Addendum 5
TFM-009-24 – GRD-508-23: Concrete & Asphalt Repairs 2024

PROJECT NAME:
CONCRETE AND ASPHALT REPAIRS 2024
Project #: GRD-508-23

Addendum 4
TFM-009-24 – GRD-508-23: Concrete & Asphalt Repairs 2024

C-1.7

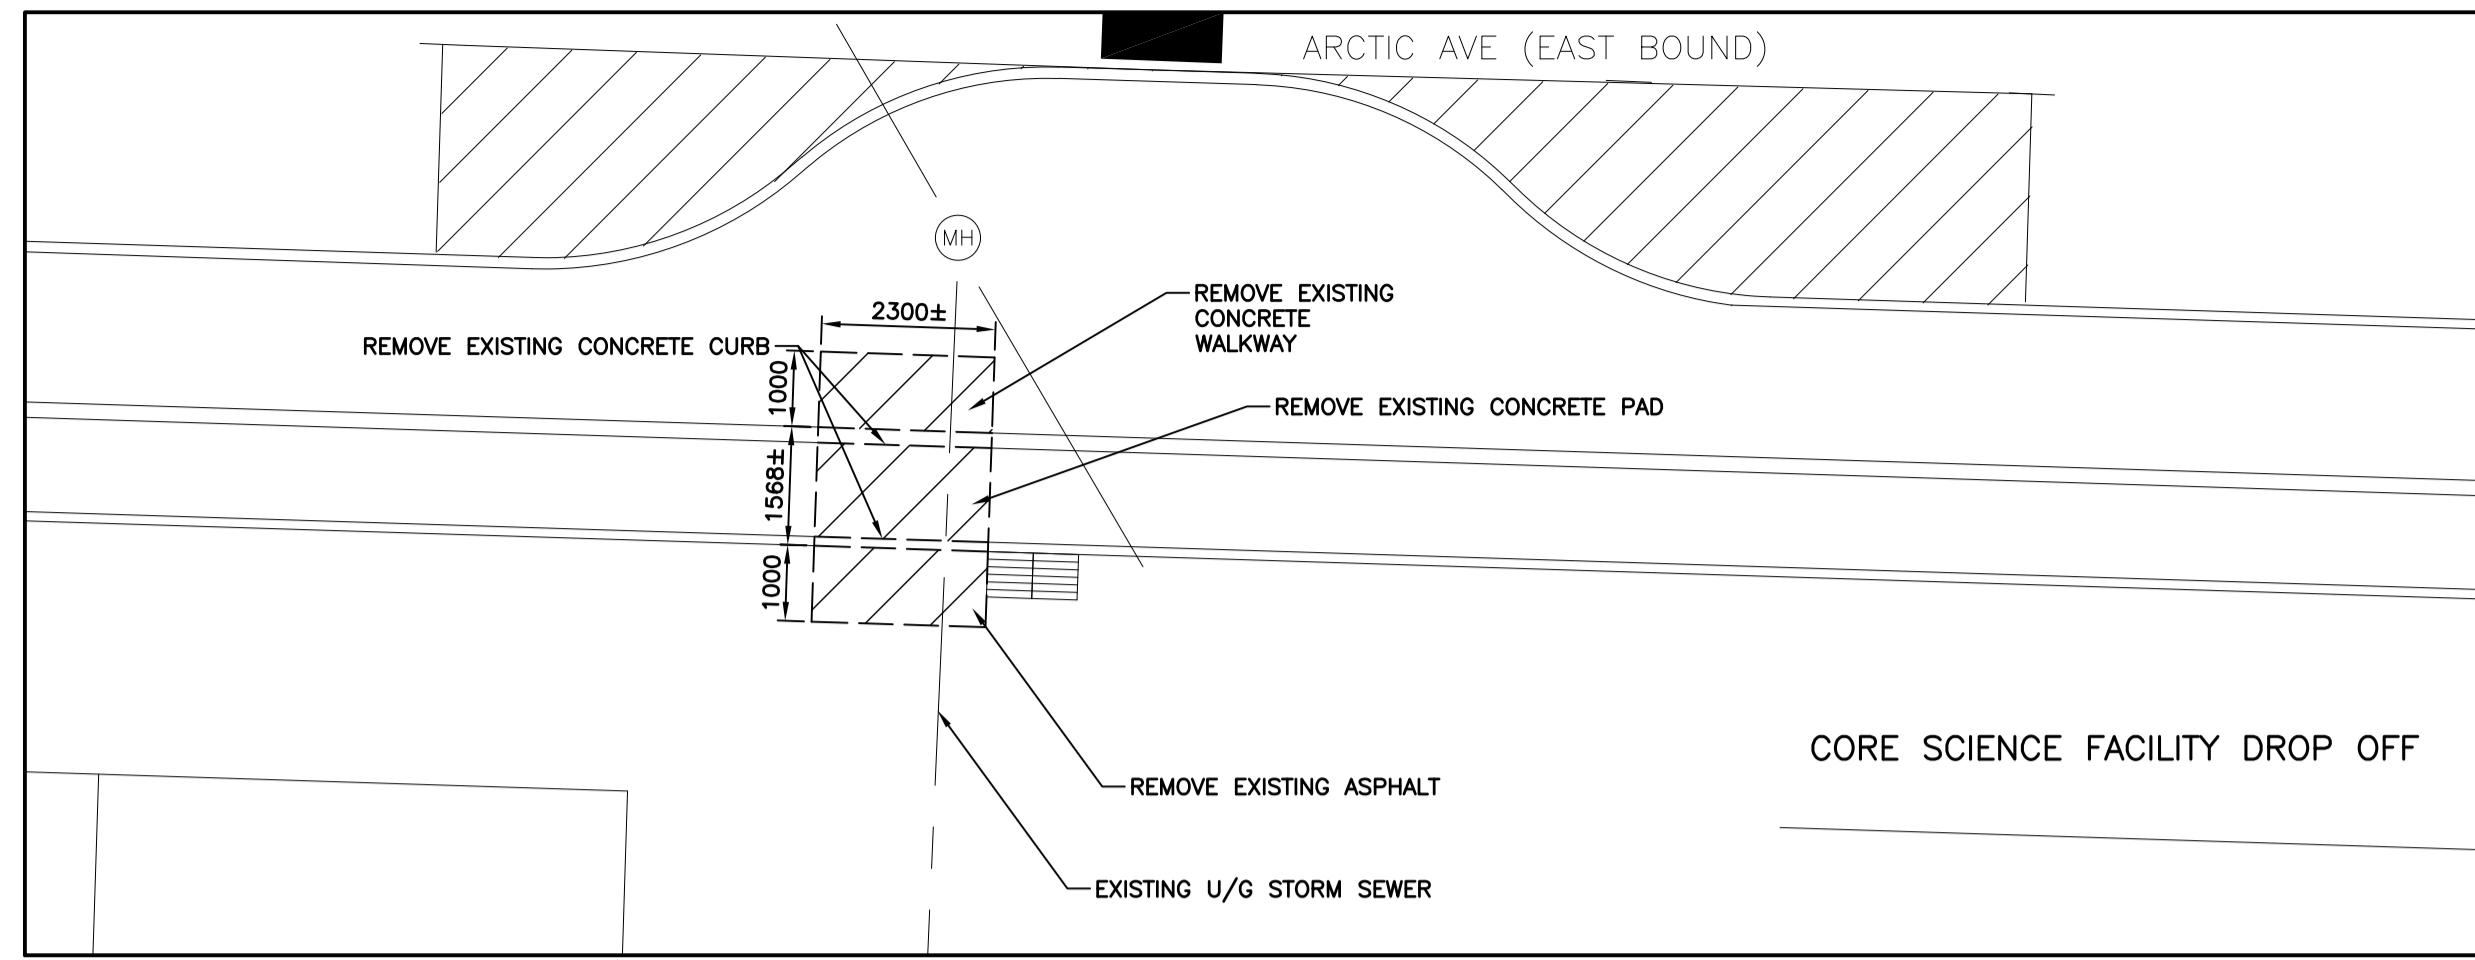
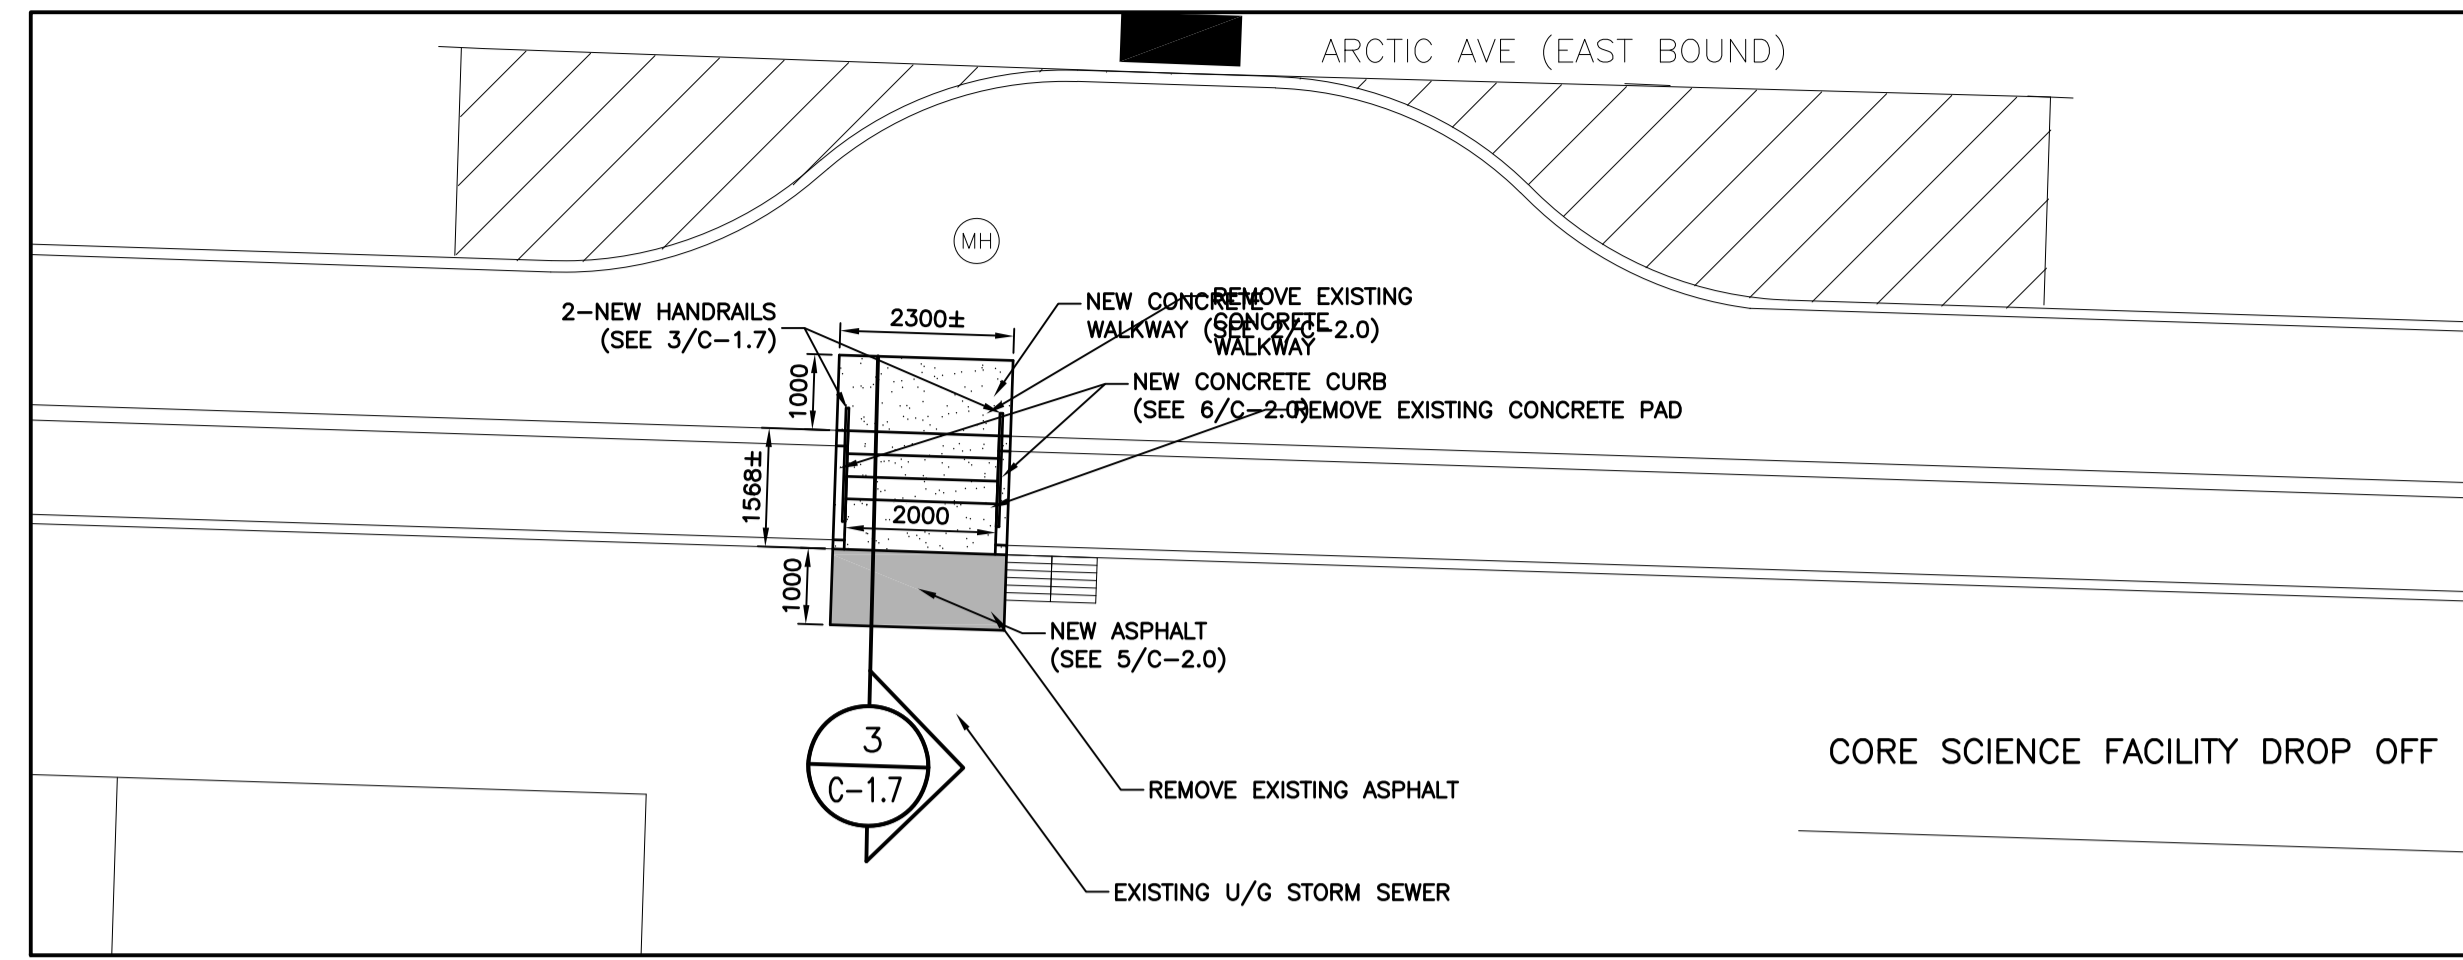
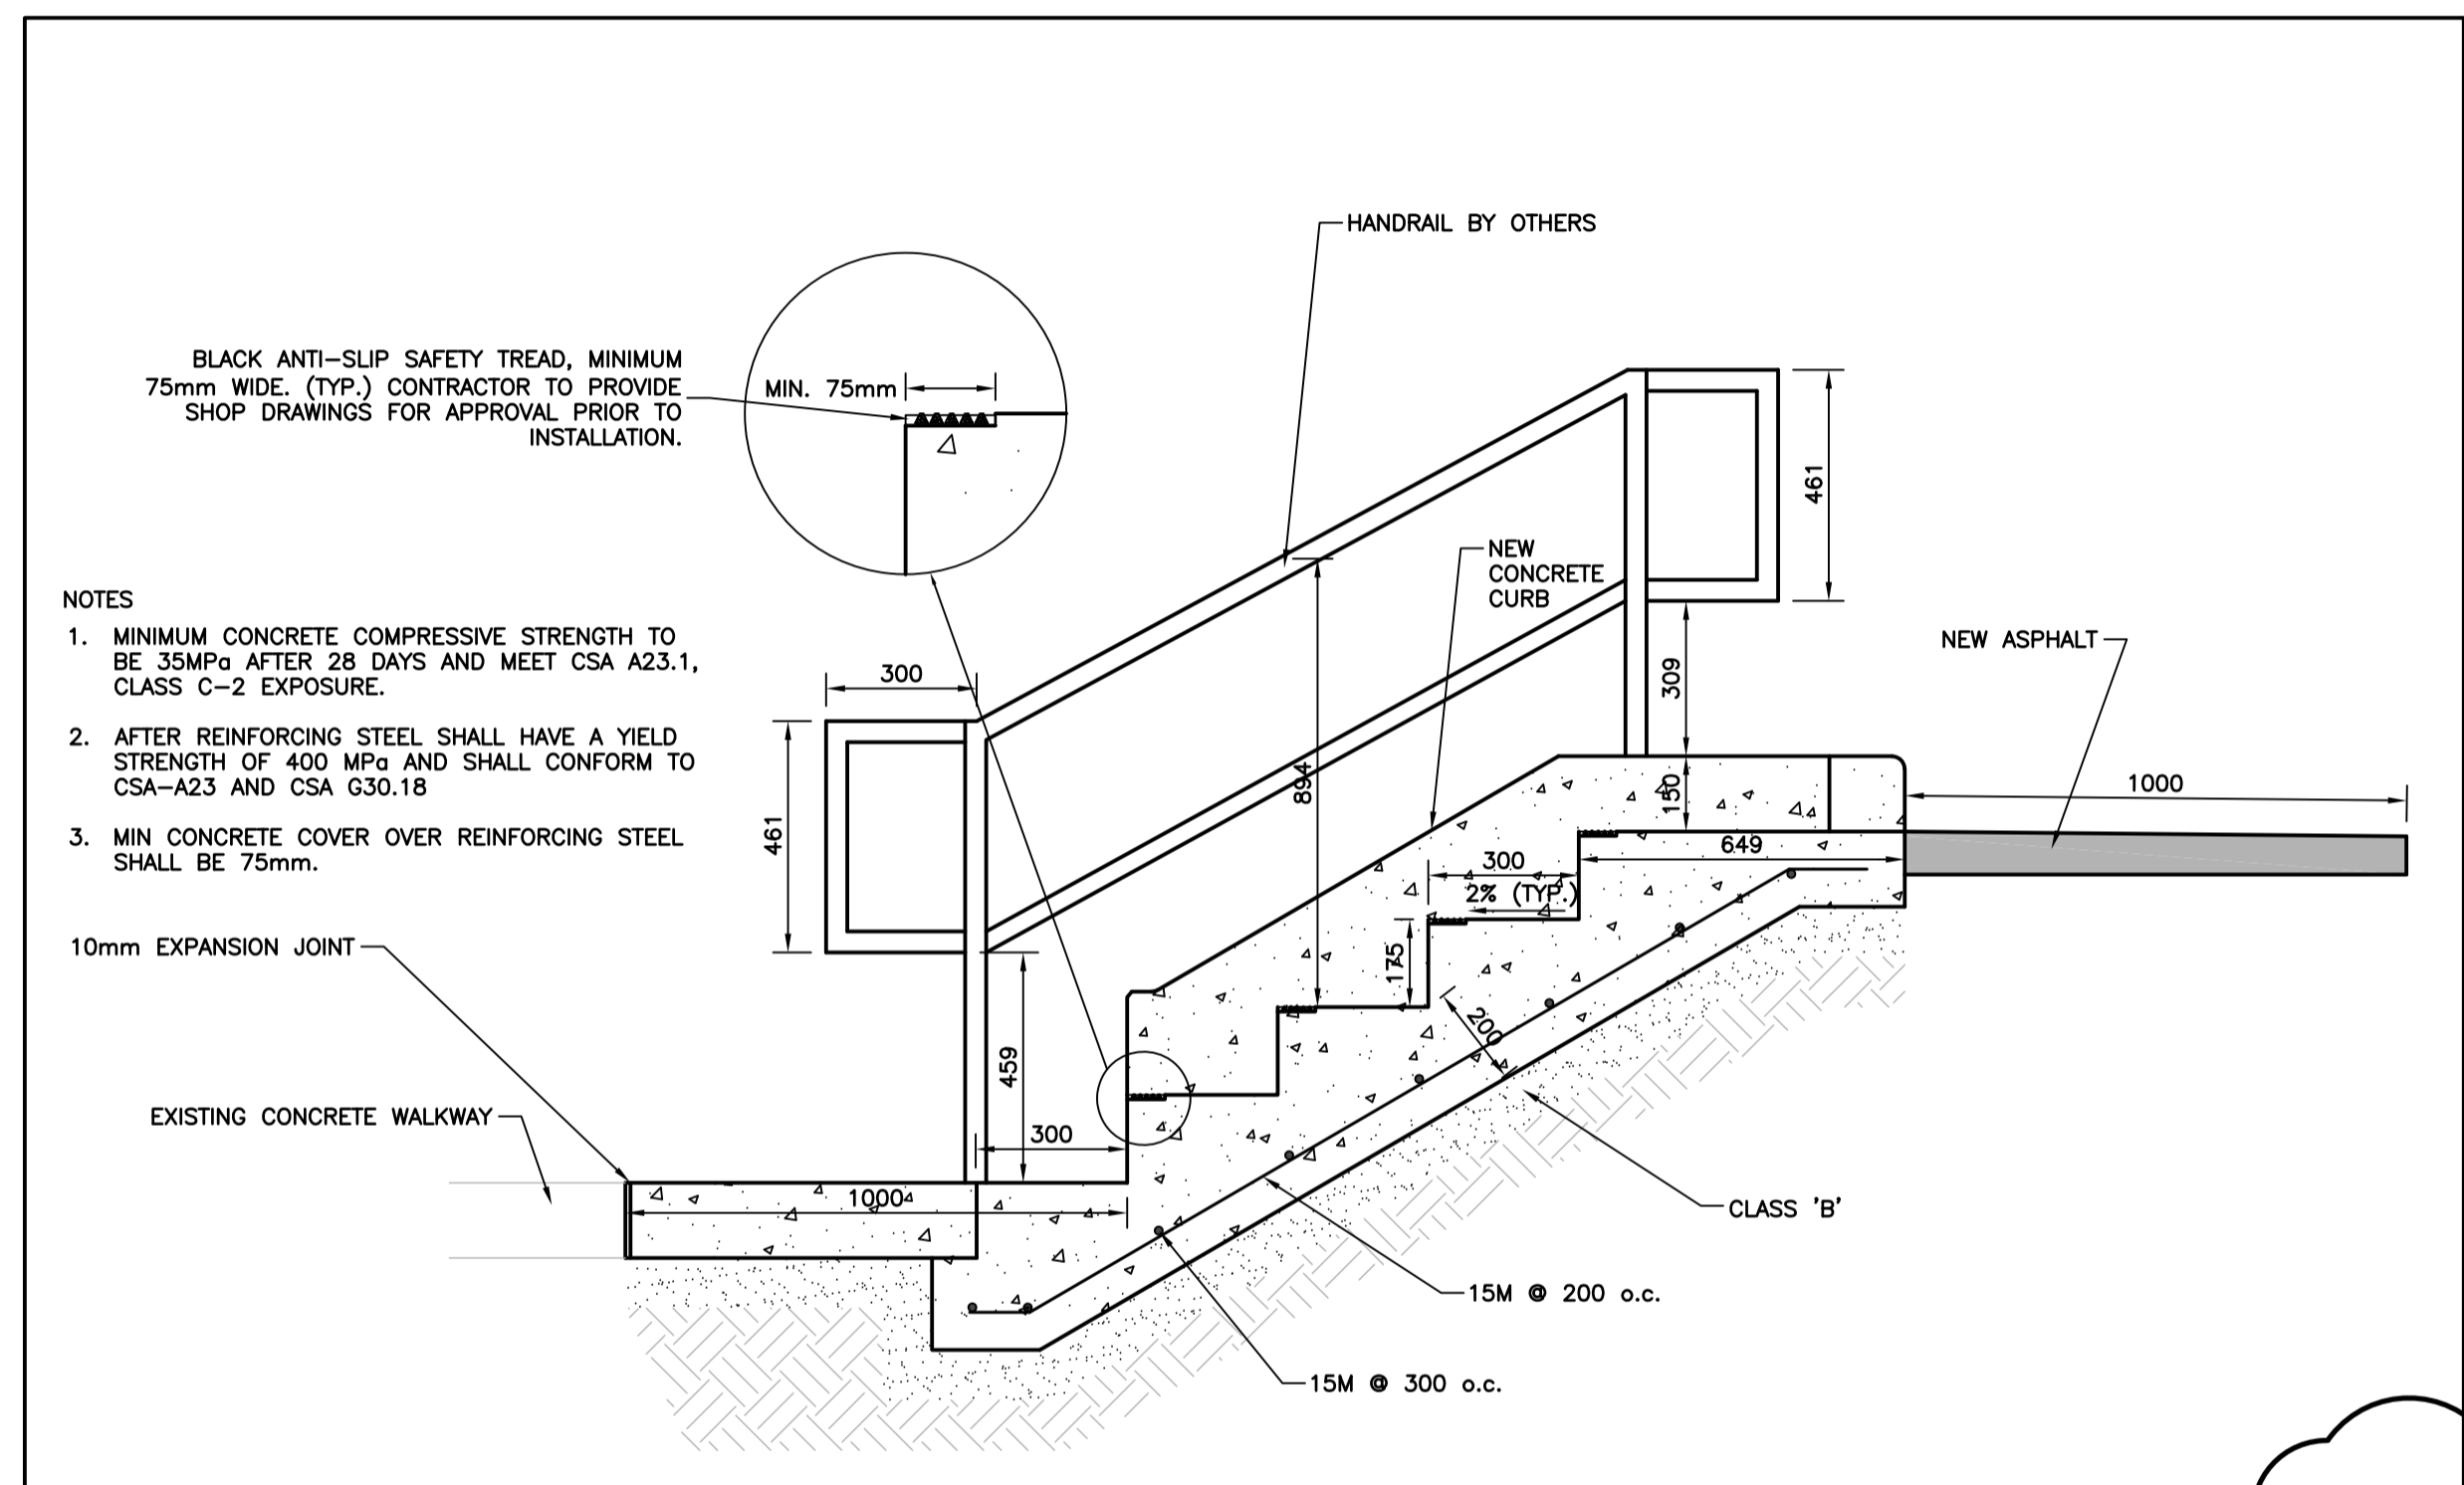
- .4 *Drawings C1.7 series do not line up with the master drawing sheet. 5 shows up as 4. 3/4 appears to be 5/6 and 1/2 appears to be 1/2/3*

RESPONSE: Drawing C-1.7 has been revised and reissued as part of this addendum.
